Addendum 94 – UN Regulation No. 95

Revision 2 - Amendment 5

04 series of amendments – Date of entry into force: 3 January 2021

Uniform provisions concerning the approval of vehicles with regard to the protection of the occupants in the event of a lateral collision

Model A
(See paragraph 4.5. of this Regulation)

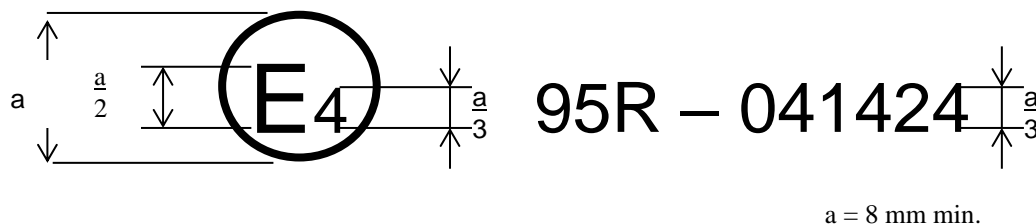
Annex 2, amend to read:

The above approval mark affixed to a vehicle shows that the vehicle type concerned has, with regard to the protection of the occupants in the event of a lateral collision, been approved in the Netherlands (E 4) pursuant to UN Regulation No. 95 under approval number 041424. The approval number indicates that the approval was granted in accordance with the requirements of UN Regulation No. 95 as amended by the 04 series of amendments.

Model B
(See paragraph 4.6. of this Regulation)

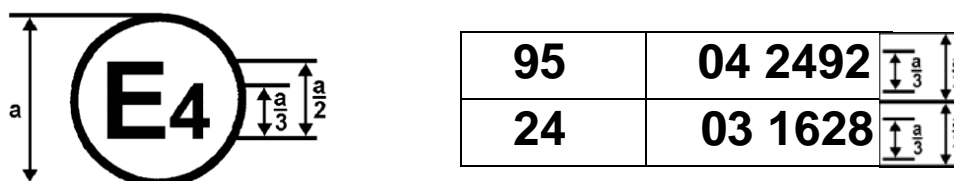
The above approval mark affixed to a vehicle shows that the vehicle type concerned has been approved in the Netherlands (E 4) pursuant to UN Regulations Nos. 95 and 24.² The first two digits of the approval numbers indicate that, at the dates when the respective approvals were granted. UN Regulation No. 95 incorporated the 04 series of amendments and UN Regulation No. 24 incorporated the 03 series of amendments."
